Product Change Notification / NTDO-23HTHI228

CCB 6113 Final Notice: Qualification of MTAI as an additional assembly site for MCP6031T-E/OT, MCP6051T-E/OT, MCP6061T-E/OT and MCP6071T-E/OT catalog part numbers (CPN) available in 5L SOT-23 package.

CCB#: 6113
Pre and Post Change Summary
PCN #: NTDO-23HTHI228

Lead Frame Comparison

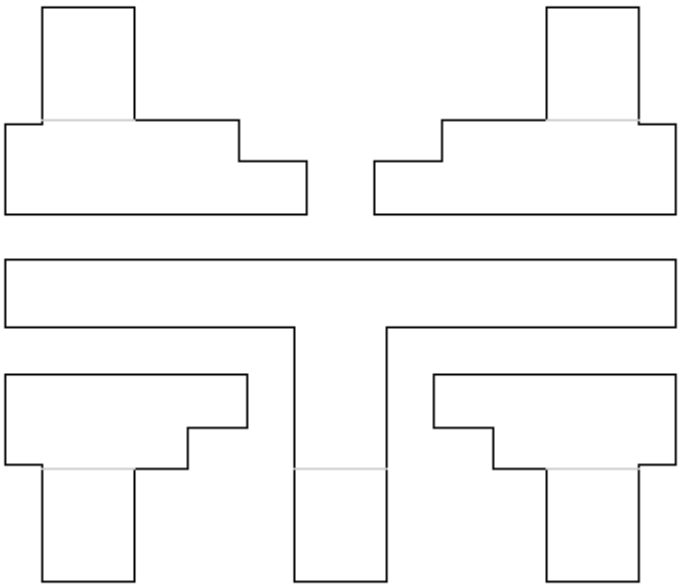
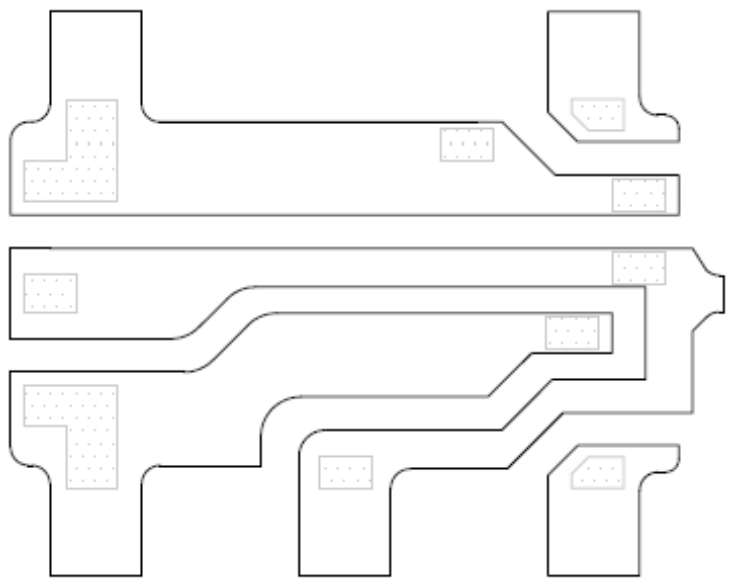
Material*	C194												
DAP Surface Prep	Ag												
Treatment	No												
Material*	CDA194												
DAP Surface Prep	Ag-selective												
Treatment	Roughening
